F180 MANUAL CORRECTIONS

Page 11, step 2.10

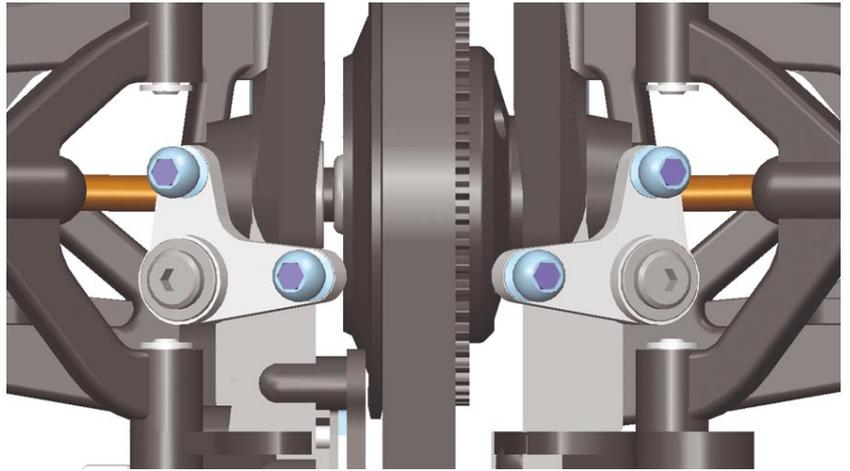
The orientation of the rear rockers is incorrect in the manual. The image on the right shows the correct orientation.

Page 20, step 4.8

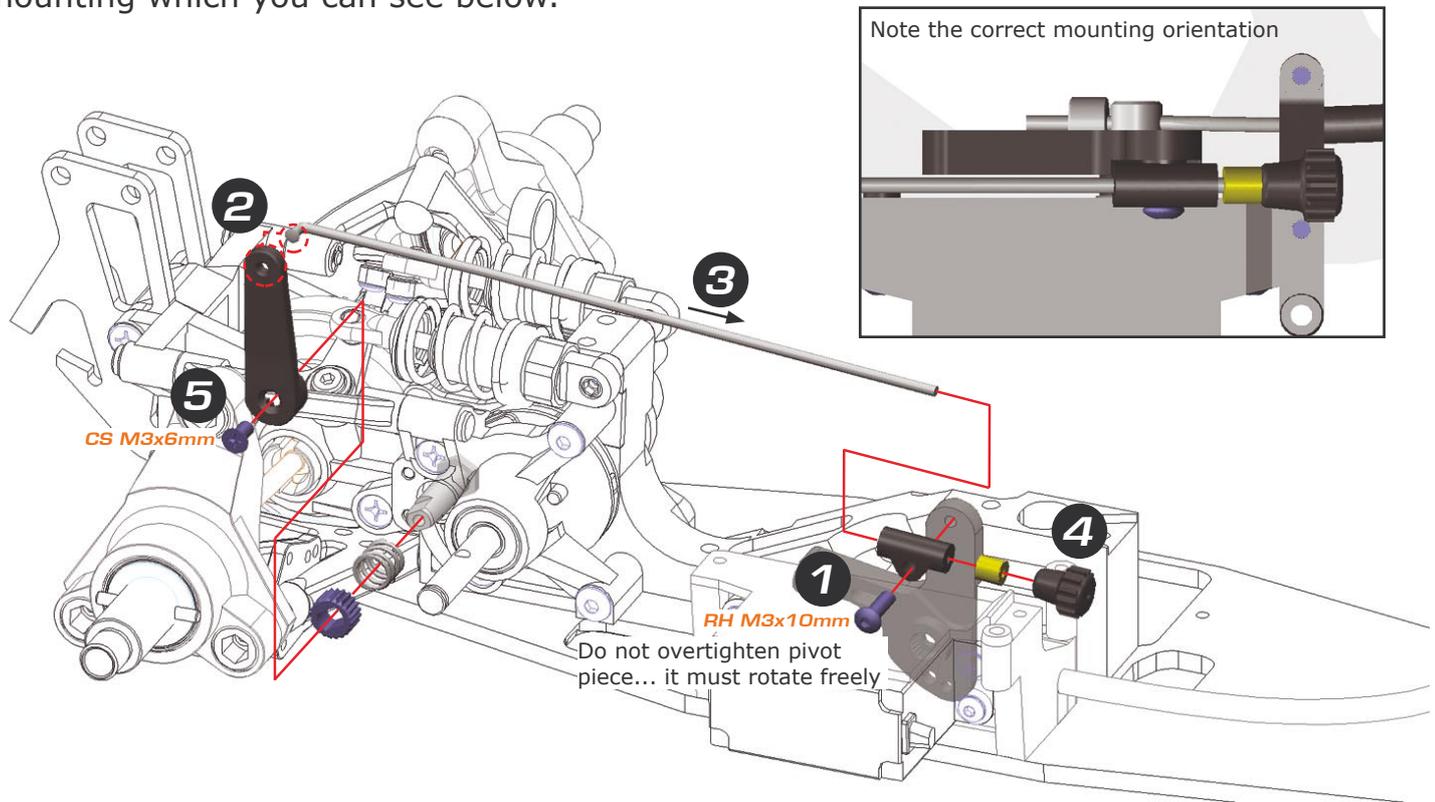
This step has a new assembly order and clarifies the brake lever and servo arm mounting which you can see below.
